From: Tomkins, James [jjetomkins@STPEGS.COM]
Sent: Tuesday, April 12, 2011 4:04 PM
To: Joseph, Stacy
Subject: Draft Follow-up Presentation to ACRS
Attachments: Chapter 6 Followup Presentation JUne - NRC.pdf; Chapter 6 Followup Presentation JUne Action Items Only- NRC.pdf

South Texas Project Units 3 & 4 Presentation to ACRS Subcommittee Chapter 6 Follow-up

Summary of Key Points from Previous Meeting

Hot Assembly Flow vs. Blockage Factor

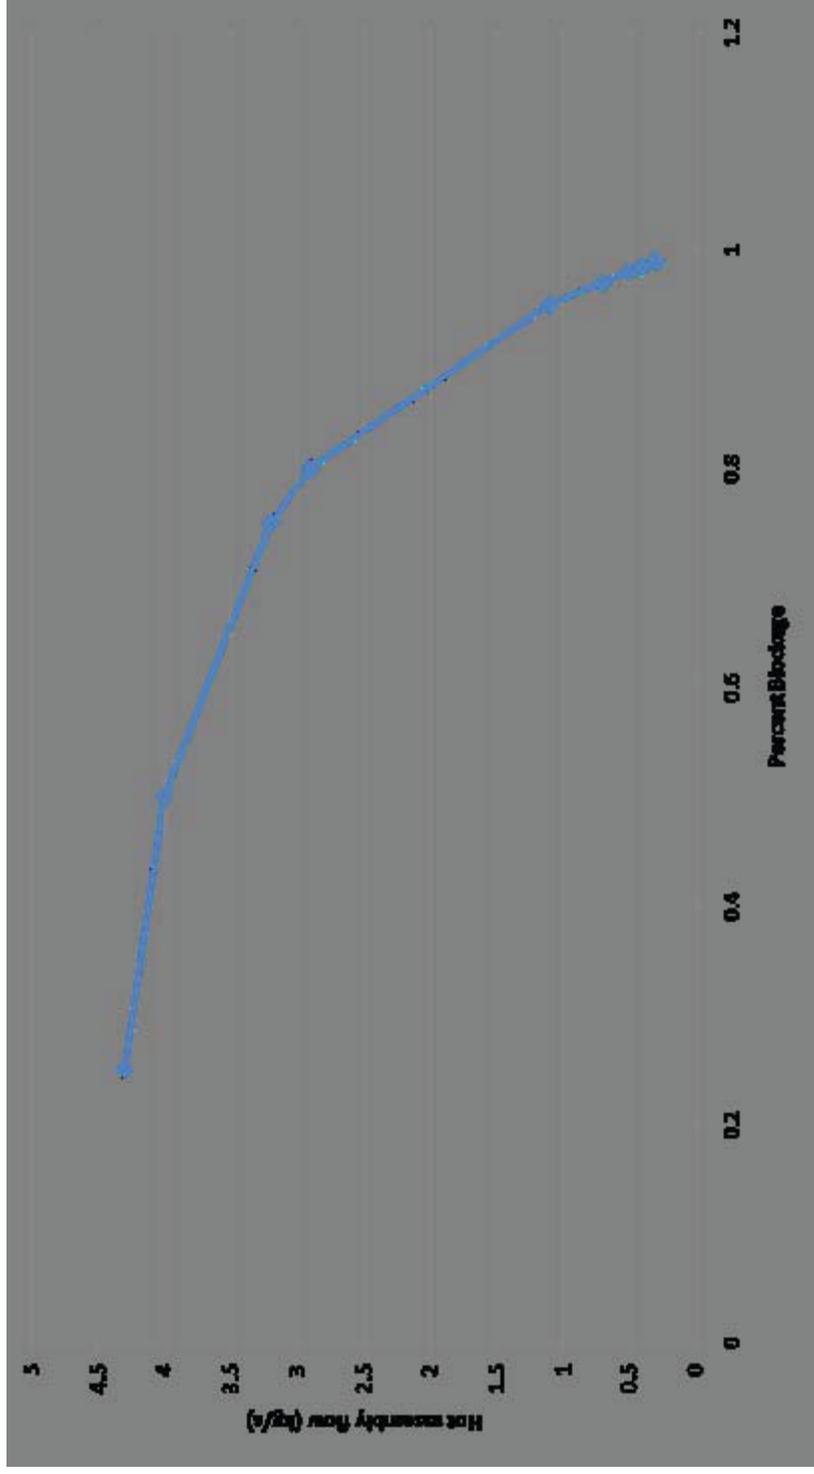
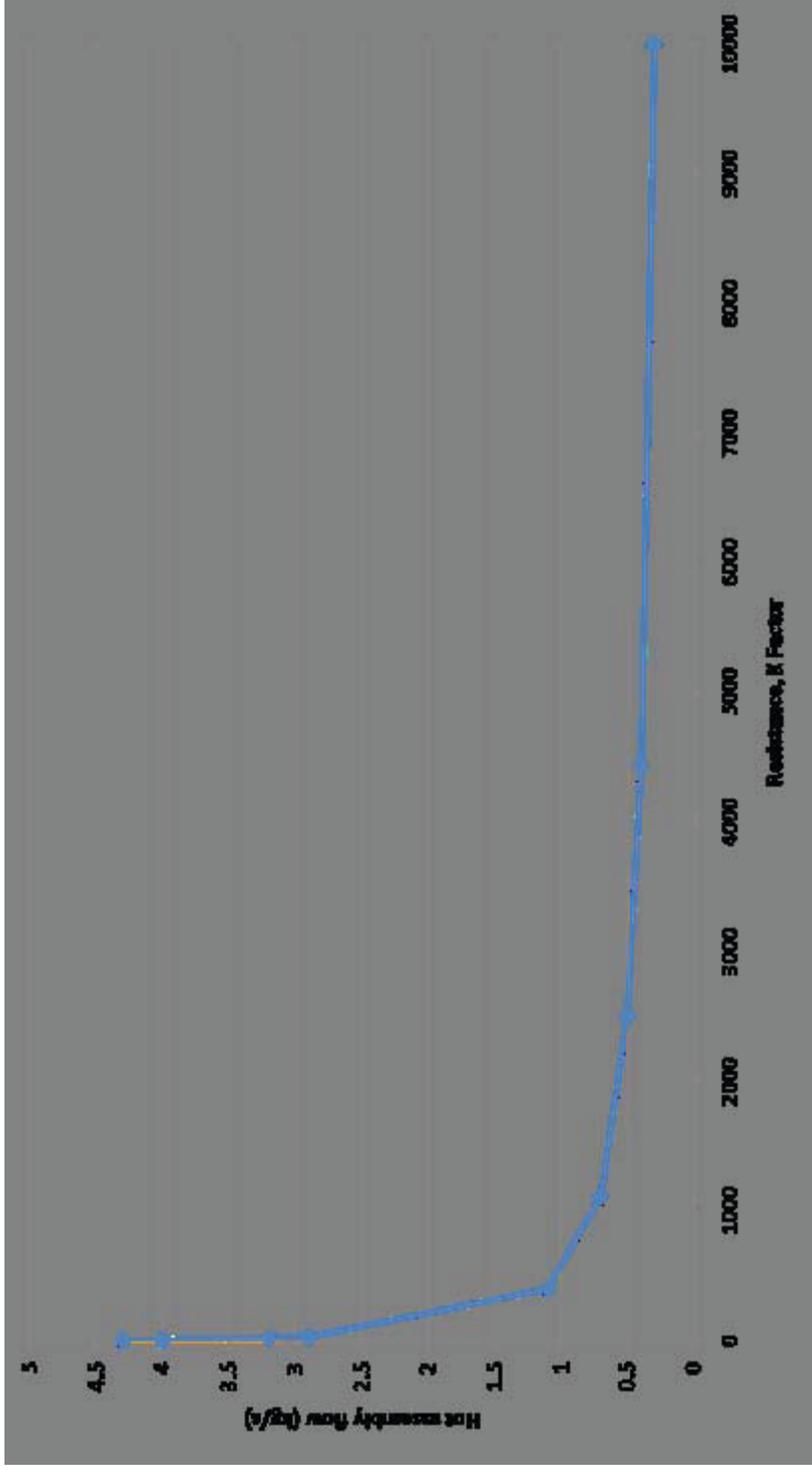
- Action Item # 84
- *ACRS requested a parametric study of k-factor vs. flow rate*

Hot Assembly Flow vs. Blockage Factor

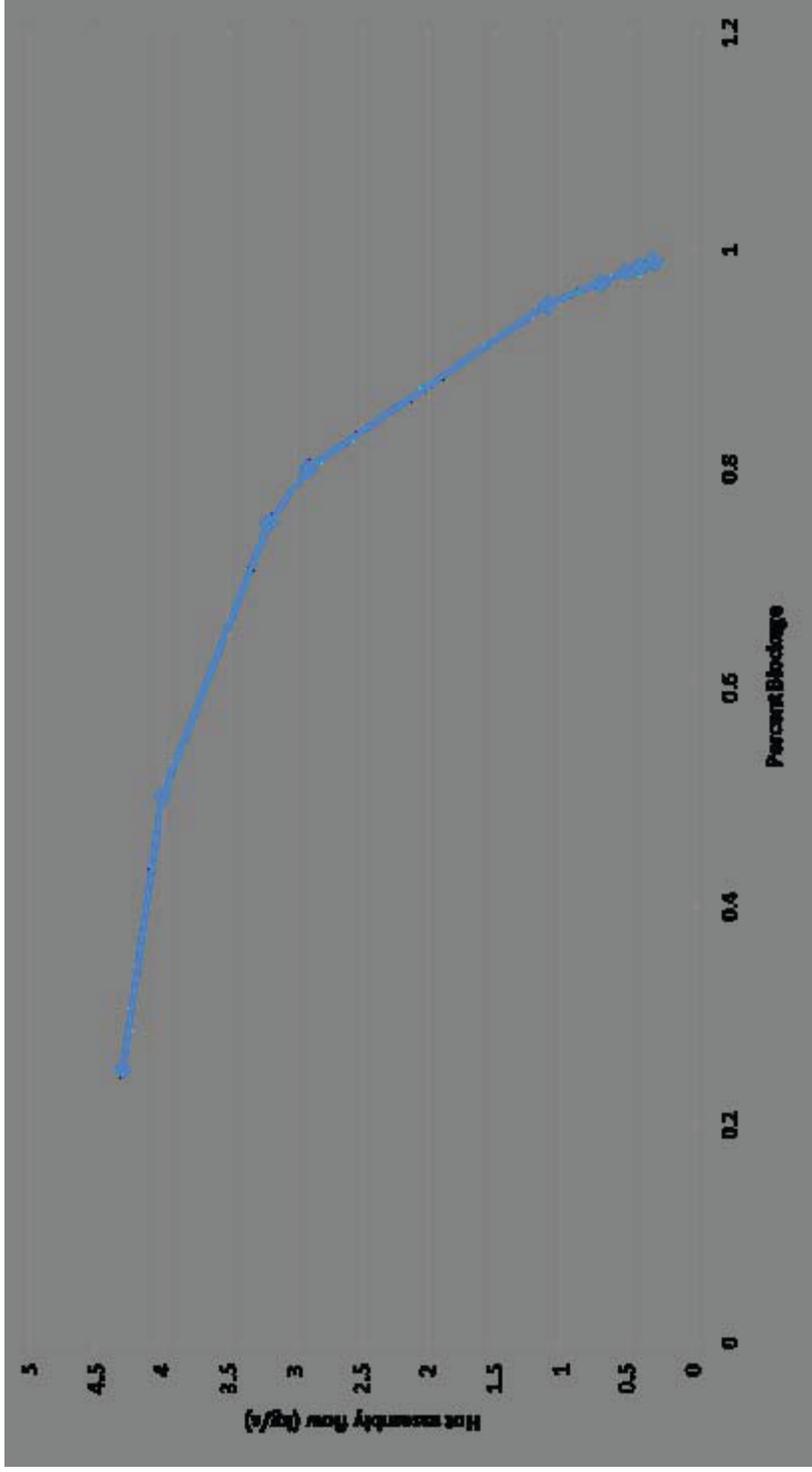
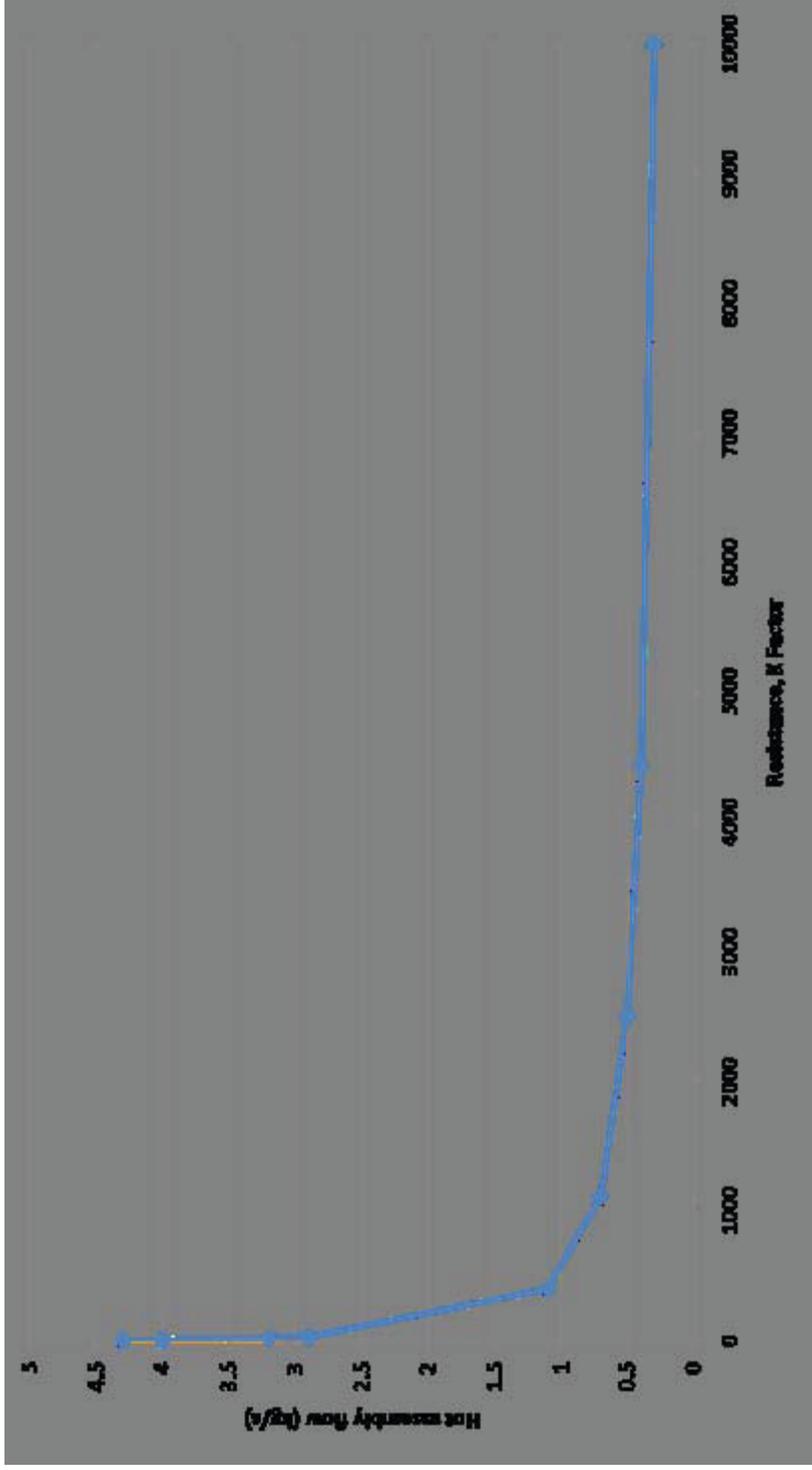
- Action Item # 84
- *ACRS requested a parametric study of k-factor vs. flow rate*
